HAMMARLUND HX-50 TRANSMITTER/EXCITER - ADDENDA

TO INCREASE VOX SENS.

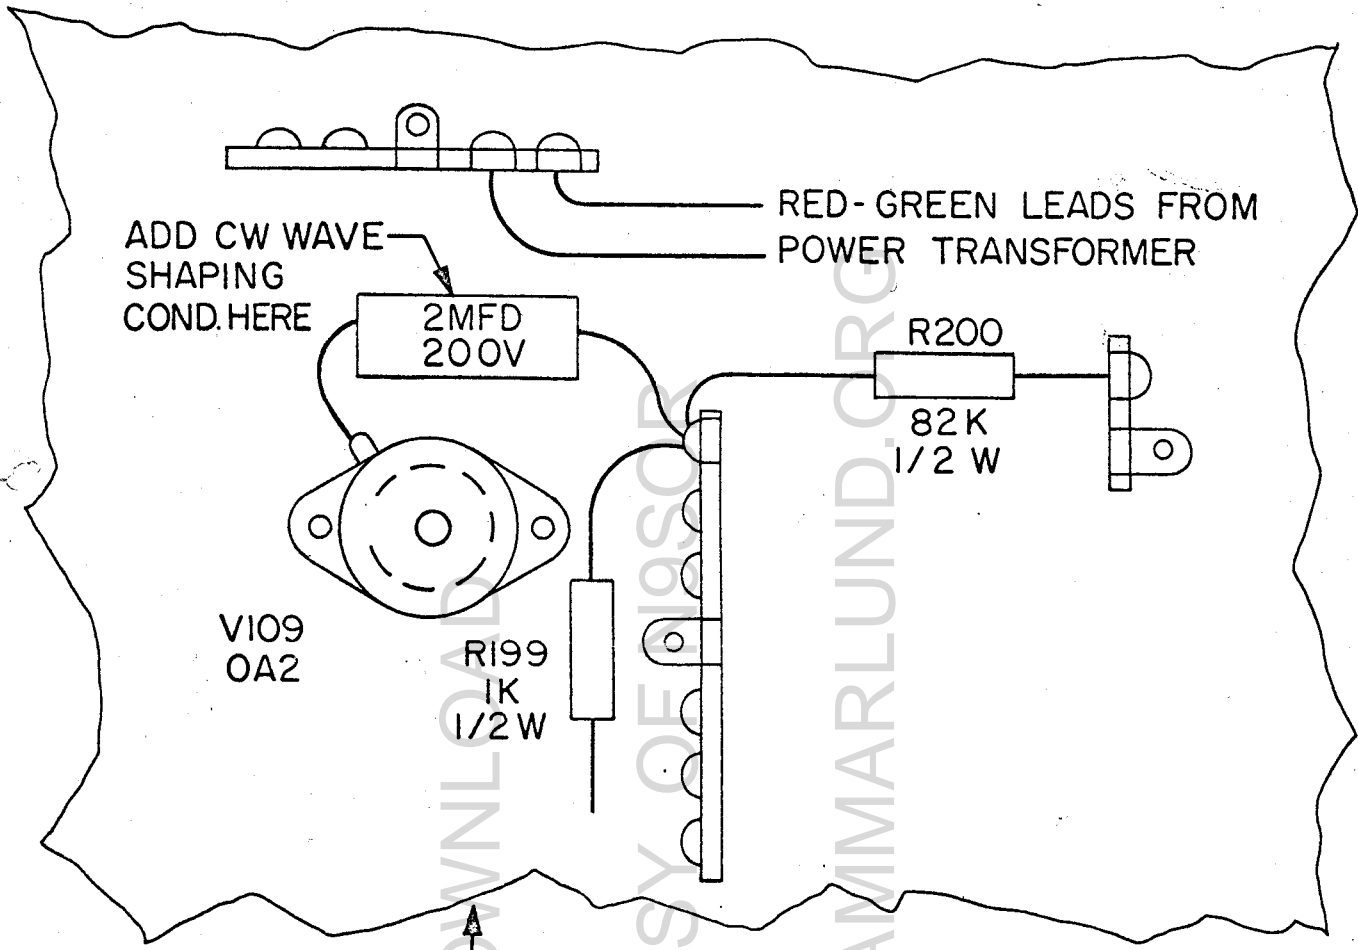
INSTALL A 47K 1/2 WATT RESISTOR BETWEEN C110 AND THE JUNCTION OF T102 AND R113. (SEE ATTACHED DRAWING).

TO REDUCE KEY CLICKS

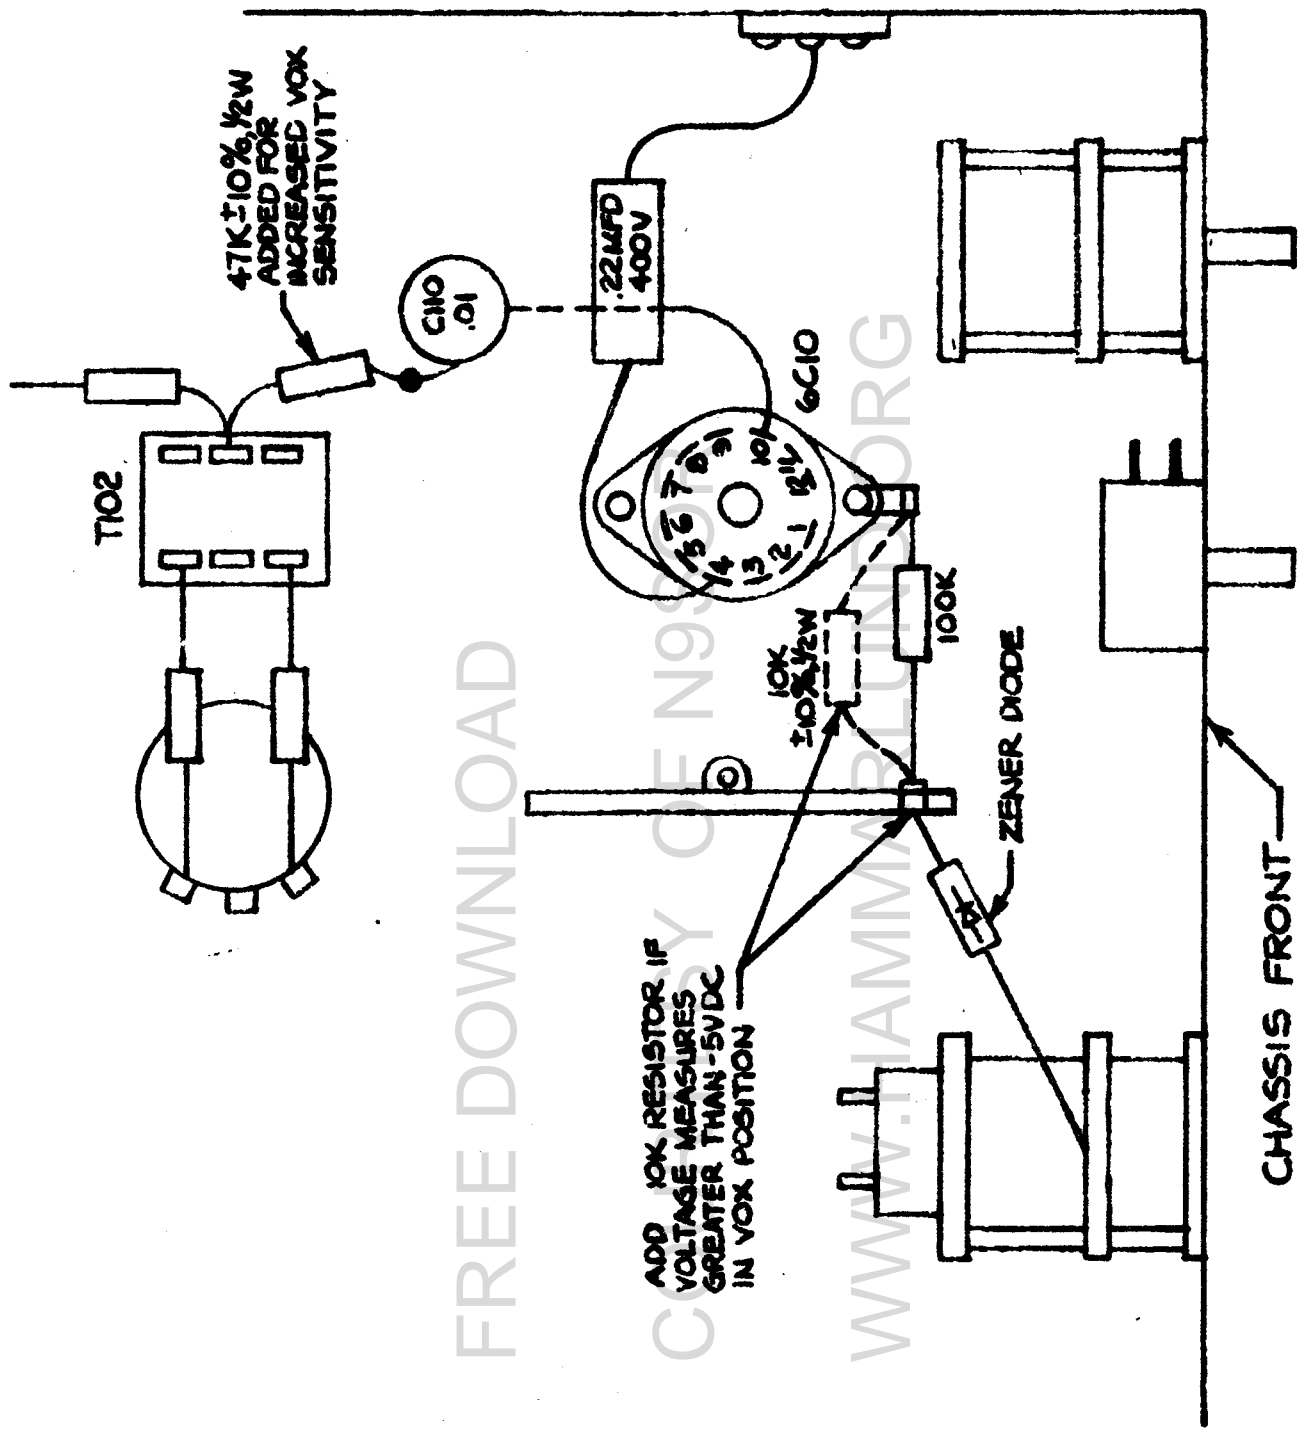
CONNECT A 2 MFD 200 V. CAPACITOR BETWEEN THE JUNCTION OF R199 AND R200 AND GROUND. (SEE ATTACHED DRAWING).

NOTE: IF A ELECTROLYTIC CAPACITOR IS USED THE POSITIVE TERMINAL SHOULD BE CONNECTED TO THE CHASSIS (GROUND).
